SLOVENSKI STANDARD
SIST EN 1993-4-1:2007/kFprA1:2014

Eurocode 3 - Design of steel structures - Part 4-1: Silos

FINAL DRAFT
EN 1993-4-1:2007

FprA1

Figure 4.2 — Corrugation profile and geometric parameters

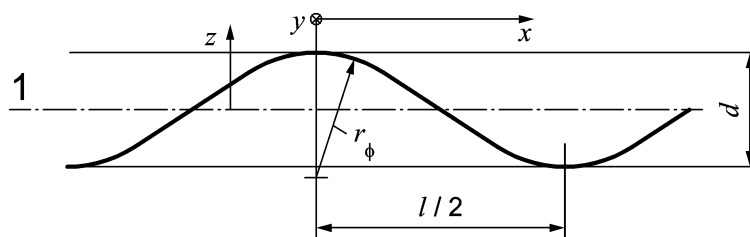
Replace Figure 4.2 with:

Key
1   effective middle surface

Figure 4.3: Corrugated sheeting and silo wall orientations

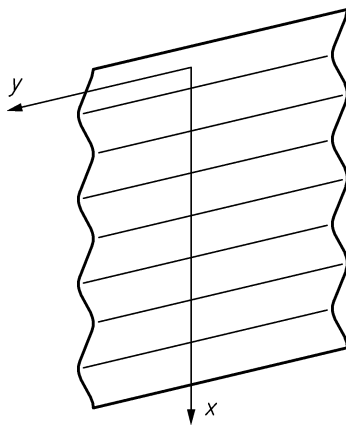
Replace Paragraph (7) with the following text and figure:

"(7) In circular silos, the corrugations are commonly arranged to run circumferentially. In this arrangement, the directions x and y in the above expressions should be taken as the vertical x and circumferential θ directions respectively, see Figure 4.3 a). In the less common arrangement in which the corrugations run vertically, the directions x and y in the above expressions should be taken as the circumferential θ and vertical x directions respectively, see Figure 4.3 b).

a) Corrugations running horizontally   b) Corrugations running vertically
